Cobb County Planning Commission 100 Cherokee Street Marietta, GA 30090

Re: Z-52 Carl Edward Dills

Attachment showing paving to be removed or where barriers to vehicle travel are to be installed.

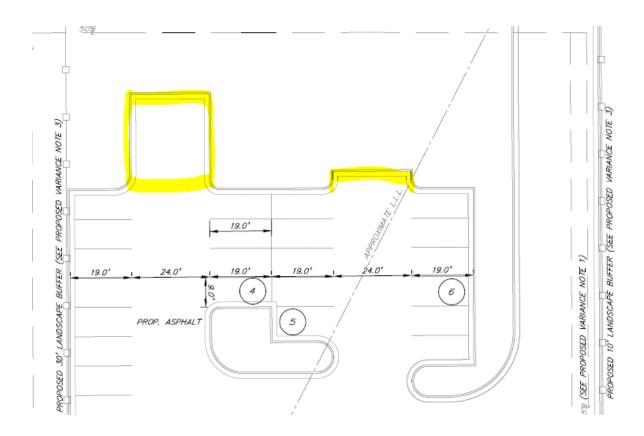
- Remove the parking lot paved aprons closest to the street and install curb, so that vehicles cannot park on the unpaved areas, as shown on the attachment.
- A prohibition against parking any vehicles on unpaved surfaces.
- No outside storage of any materials, products, or debris.
- Any sign along the frontage must be monument style, in conformance with the county ordinance.
- The color of the metal roof and metal walls will be approved by the District Commissioner.
